\*\* Please find our response highlighted in blue to the reviewer's comments.

This paper established the method for quantitative assessment of GLOF risk by combining Random Forest model to extract lake surface area, well-established Bayesian regression models to estimate glacial lake volume and peak discharge of outburst flood, hydrodynamic flood modelling, and damage analysis. Then the framework was applied to assess 21 glacial lakes in the Nepal Himalaya. I enjoy reading the methodology and believe it will contribute greatly to the quantitative assessment of the glacier lakes in the Himalaya with data sparsity. However, several major issues still need to be addressed carefully before further consideration of publication for this manuscript.

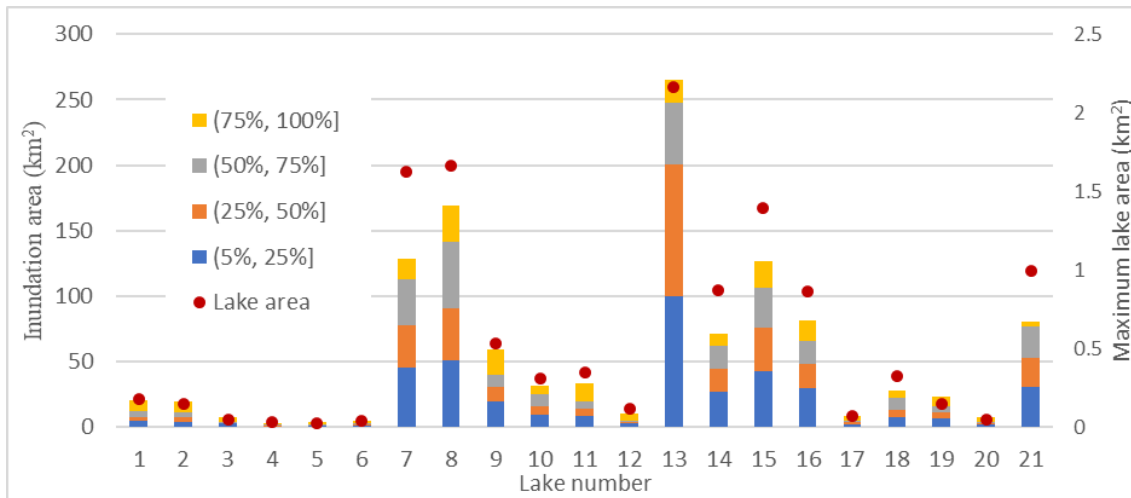
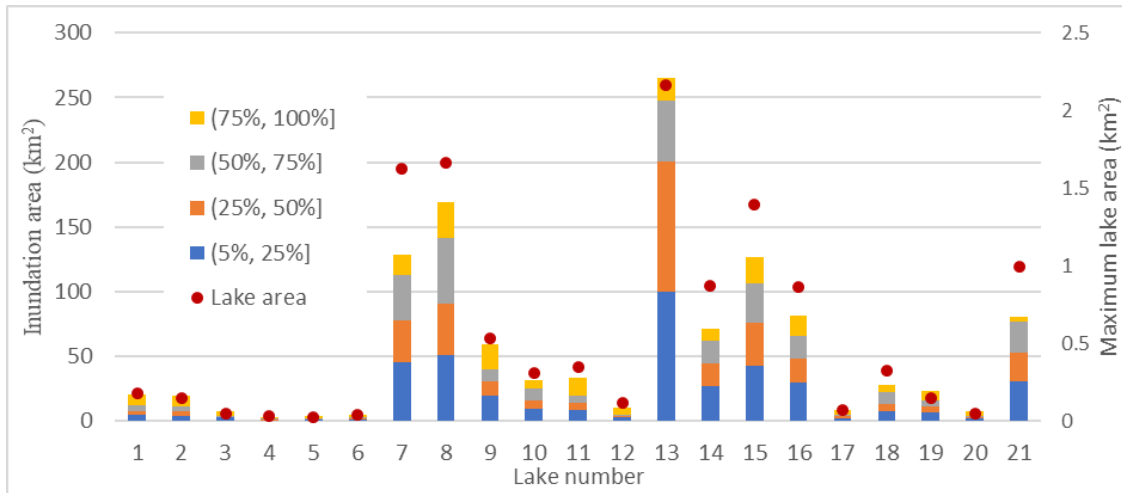
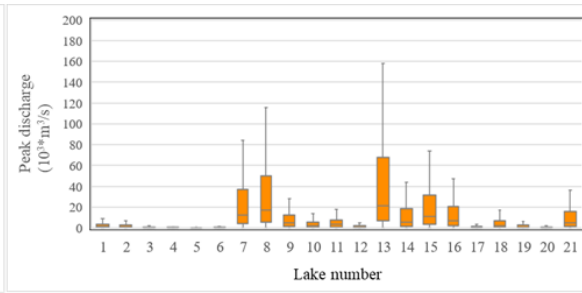
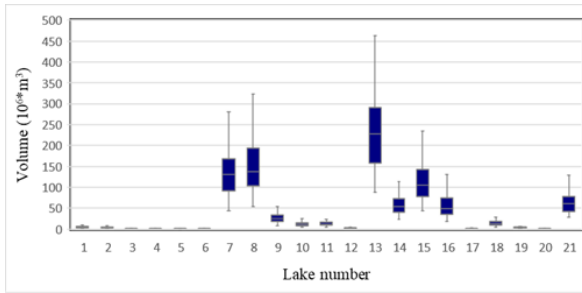
Also, figures need to be refined. Figures 4, 6, 7 and 8 do not show any ticks on the axes while the flow directions should be marked in figure 5.

Response: Ticks have been added to the axes in Figures 4, 6, and 7, shown below. Figure 8 has been removed due to the new analysis of the GLOF simulation and impact results based on the comments from the other reviewer.

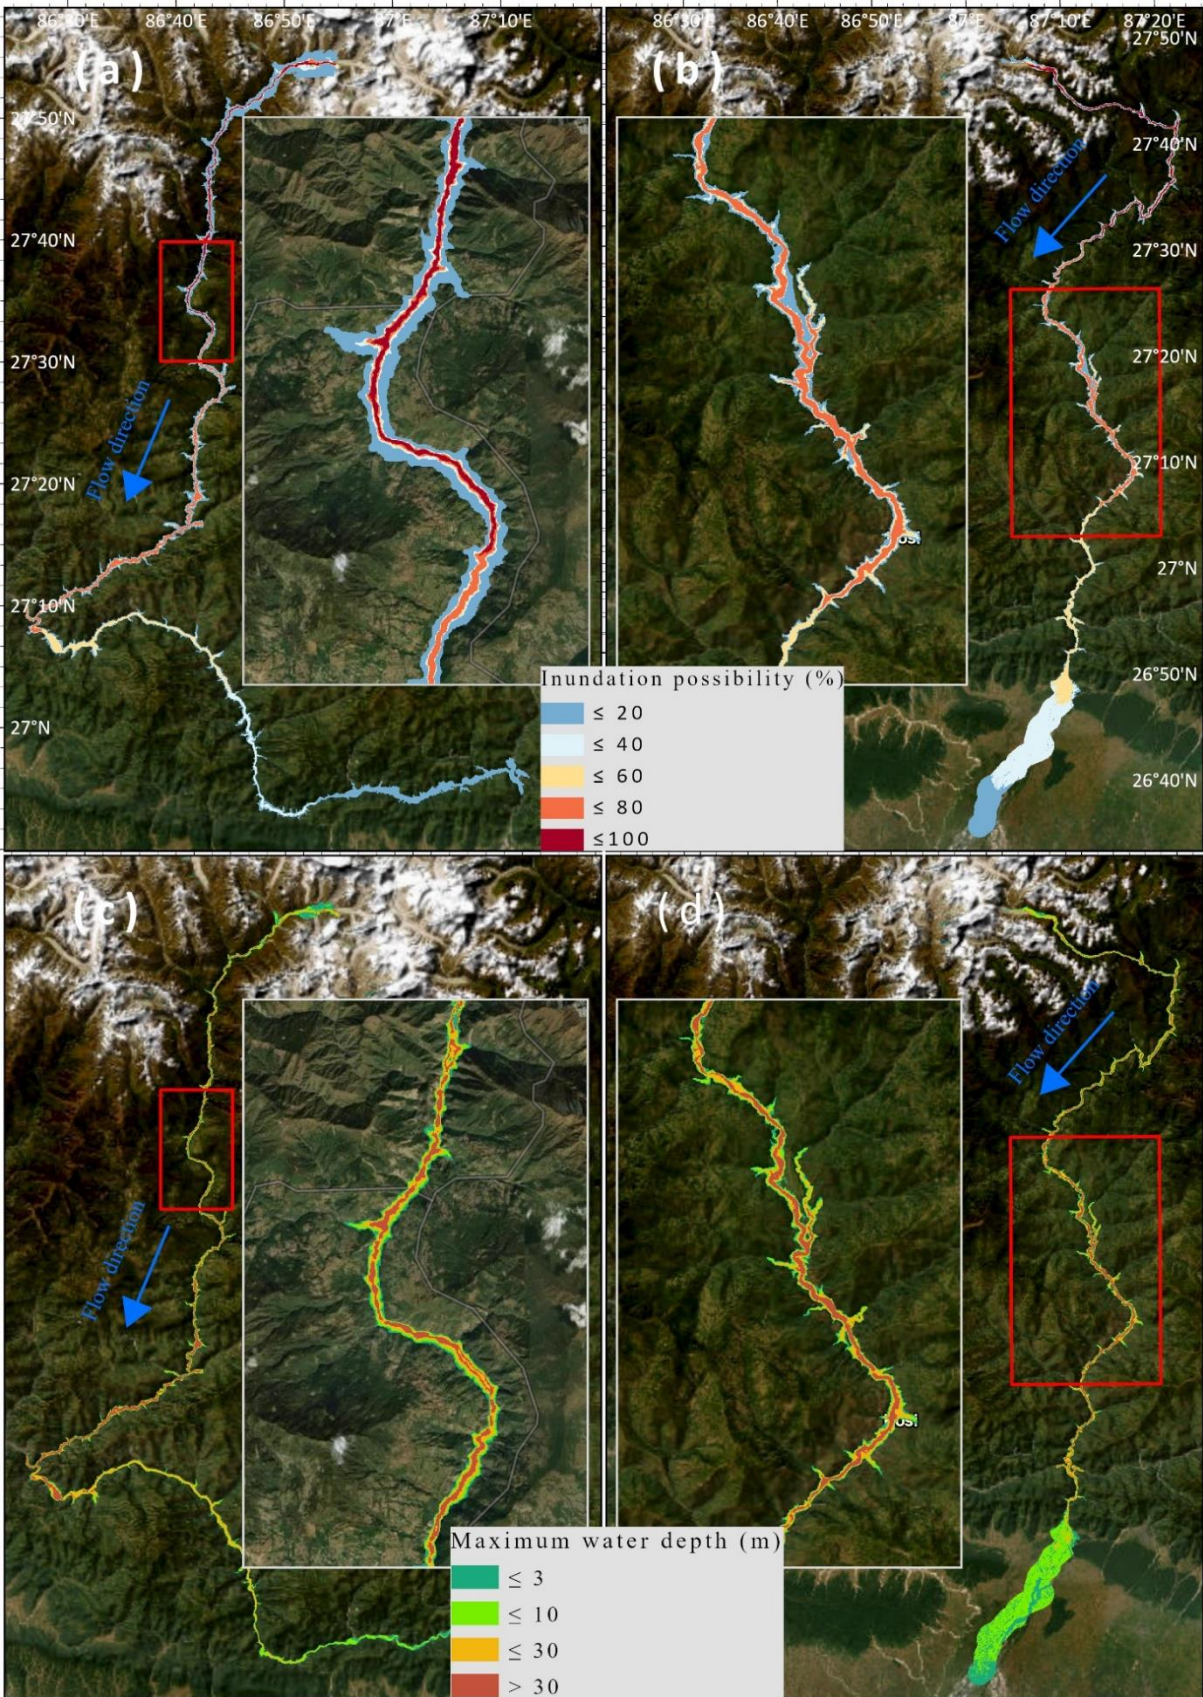
Figure 5: The locations of inset plots in the big map need to be marked.

Response: The locations of inset plots have been marked as below.
